# **MyGarage @ Northcrest PPR PCD No. PPR2412, AL234**

Re: **MyGarage @ Northcrest: Traffic Memorandum**  
**El Paso County, CO**

**DEVIATION REQUEST  
AND DECISION FORM**

Project Name :	Northcrest Flex Space PPR
Schedule No.(s) :	53323 09 004, 53323 09 005, 53323 09 006,
Legal Description :	Lot 3, Lot 4 & Lot 5 Northcrest Center Filing No 2

1 OVERALL SITE PLAN  
AS100 1" = 20'-0" (RE: 3 / A110)

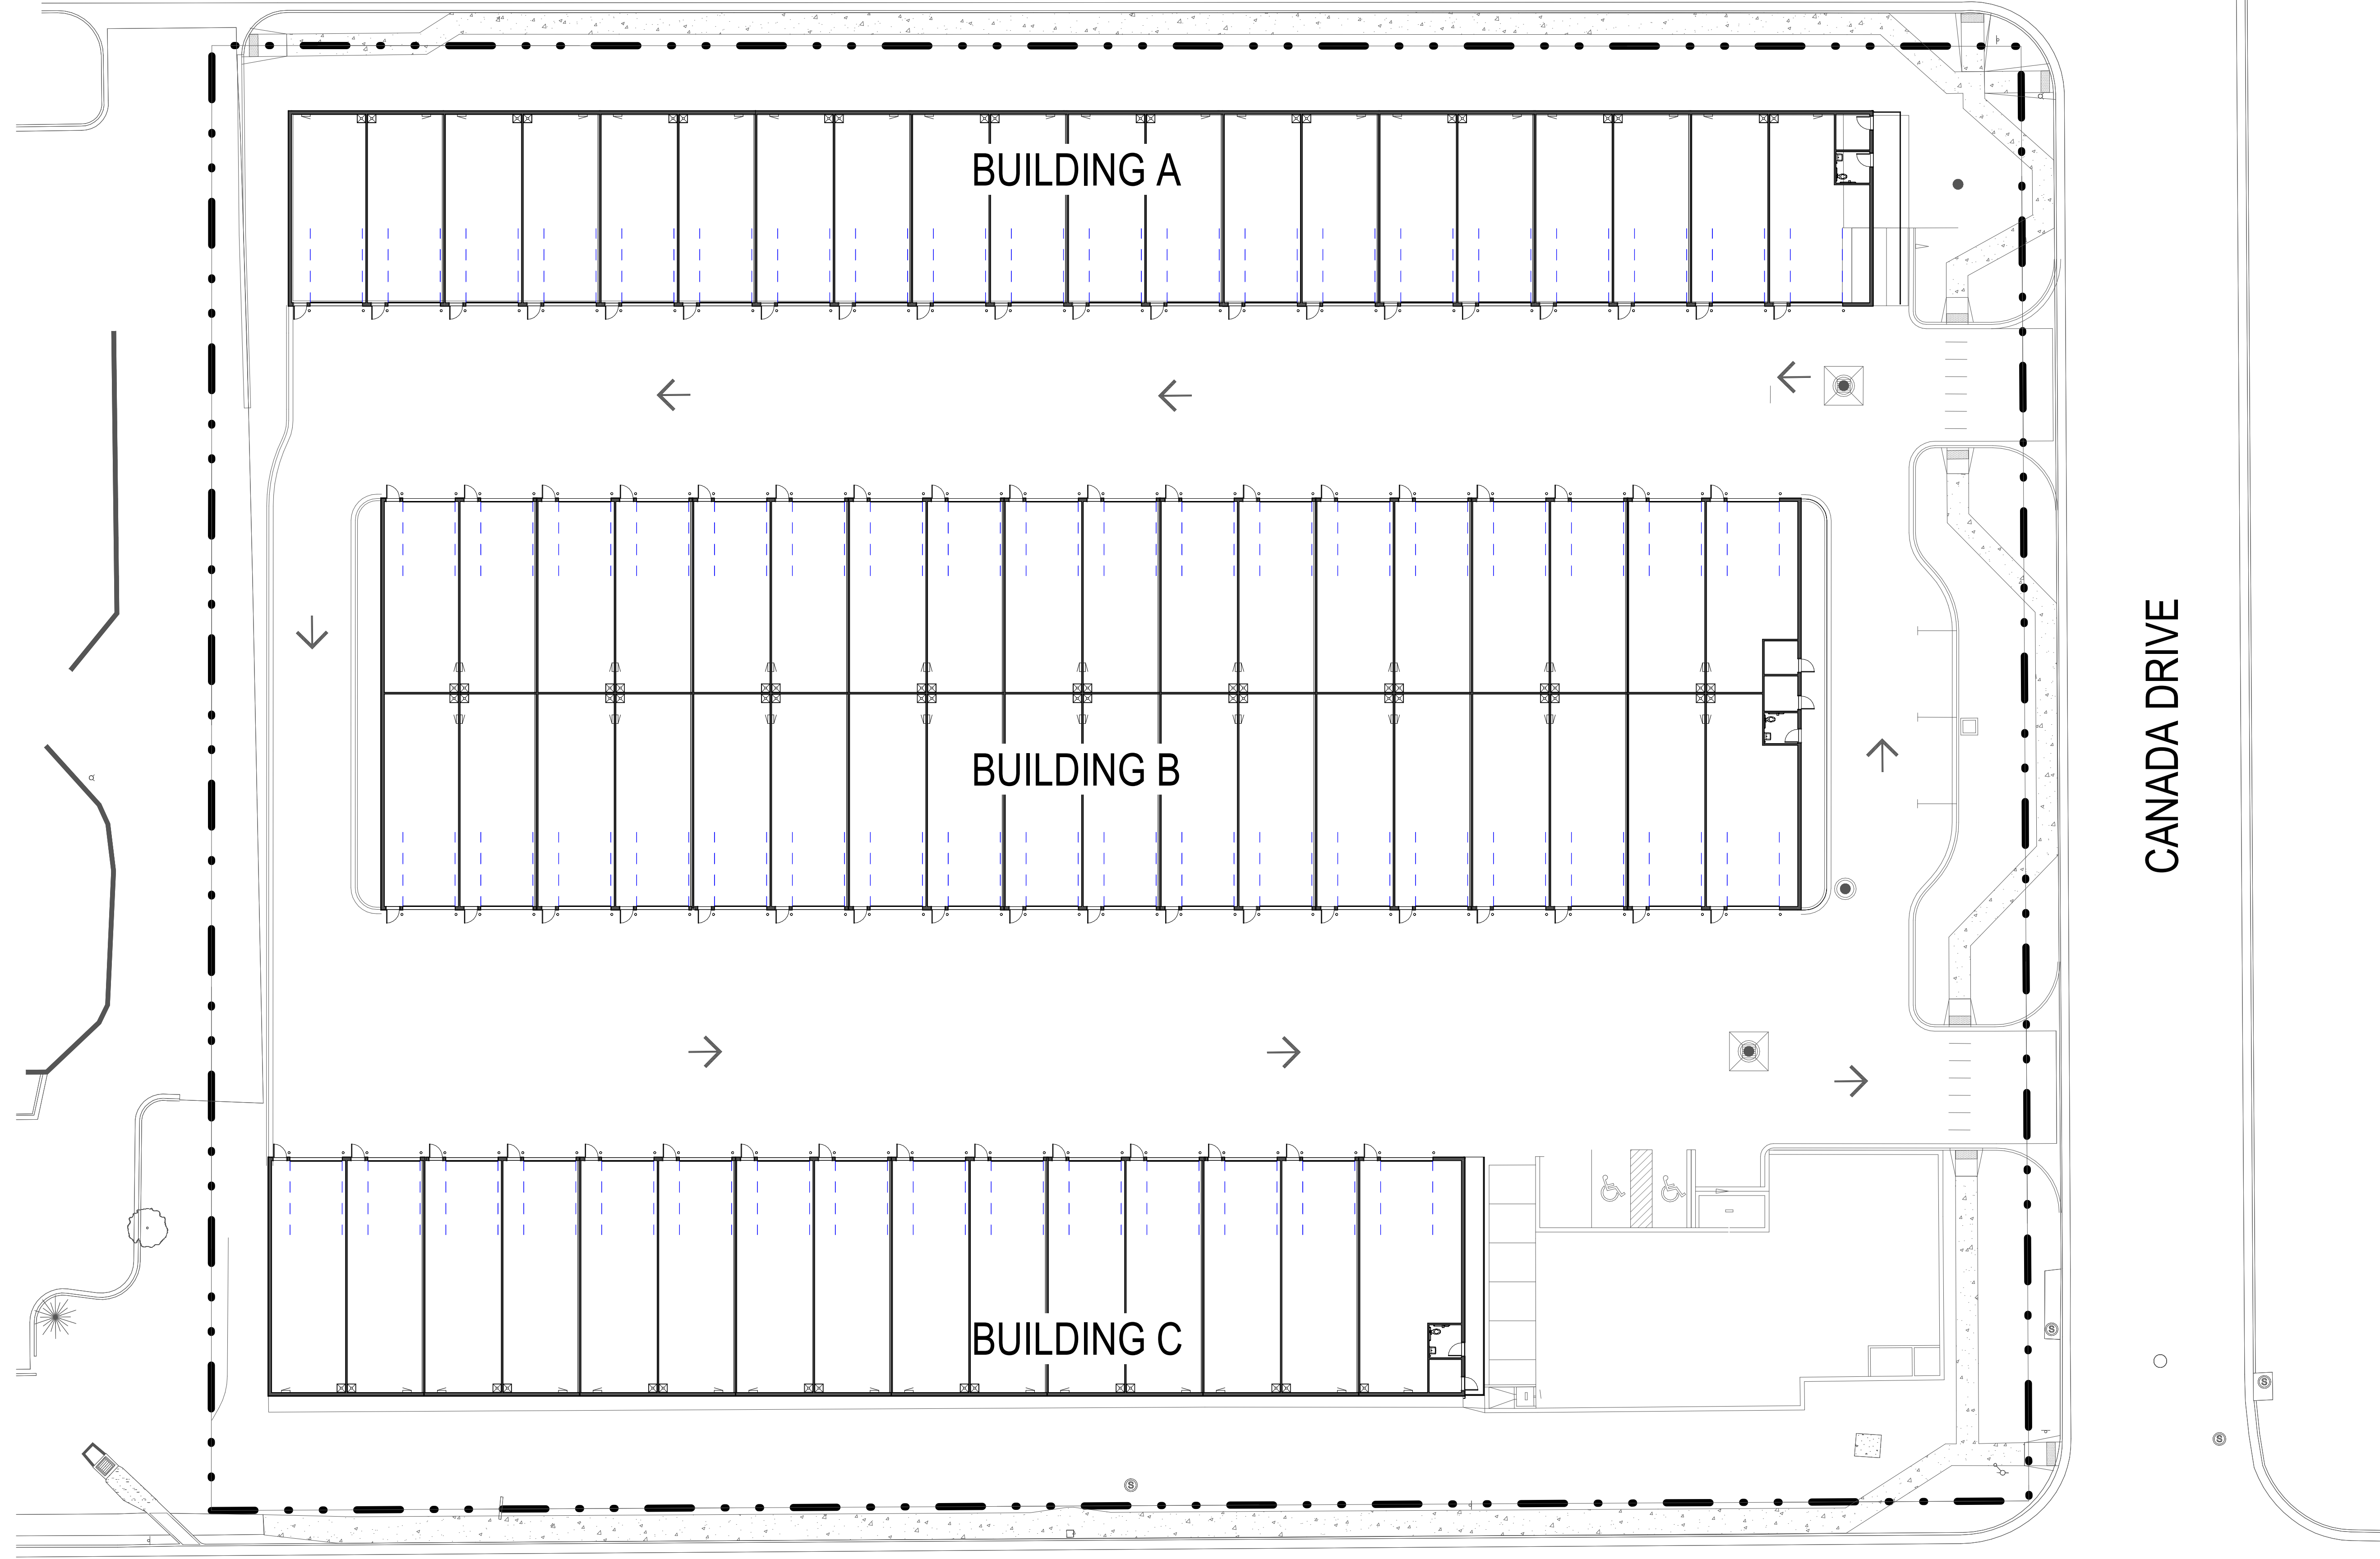
A deviation from the above is being requested for the southern and northern proposed accesses located along Canada Drive. The total site frontage along this roadway is less than 450'. It is necessary to the on site and neighboring property uses to maintain two accesses along the frontage. The two accesses have been designed to separate passenger vehicle and large truck traffic to facilitate safety. Passenger vehicles will primarily use the access to the south while larger single unit trucks would use the access to the north. Additionally, an easement is provided to the west of the site that shares access with a day care use. It is the intent of this design to minimize the necessity of any and all traffic in the proximity of the day care use.

Southern Access: The southern access, which is intended for passenger vehicles and the pedestrian accesses to the building, is proposed to be right-in/right-out along Canada Drive and connecting to the existing shared access off of Bismark Road to the west. The southern access is intended to only be used by passenger vehicles and pickup trucks. According to Section 2.4.1B Table 2-35 the Entering Sight Distance for Driveways for a 25 mph road and a single unit truck is 325'. A measure of sight distance for this entrance shows approximately 140' to Constitution Avenue. This represents a reduction from the standard of 185'. As the entrance is proposed right-in/right-out no conflicts exist with traffic coming from Constitution Avenue so no safety concerns are anticipated.

Northern Access: The northern access, which is intended for the loading traffic, is proposed as full movement along Canada Drive and connecting to the shared access off of Bismark Road to the west. The northern access is intended to be used by pickup trucks and single unit trucks. It is not anticipated that any multi unit trucks would use this access. As such and according to Section 2.4.1B Table 2-35 the Entering Sight Distance for Driveways for a 25 mph road and a passenger car vehicle is 325'. A measure of sight distance for this entrance shows approximately 255' to Constitution Avenue. As measured from Centerline to Centerline approximately 140' spacing between the southern and northern access is proposed.

Approved with the following conditions:  
Southern access entrance along Canada Drive to be right in/right out only and have a sign(s) posted according to MUCTD limiting turns and vehicle size.
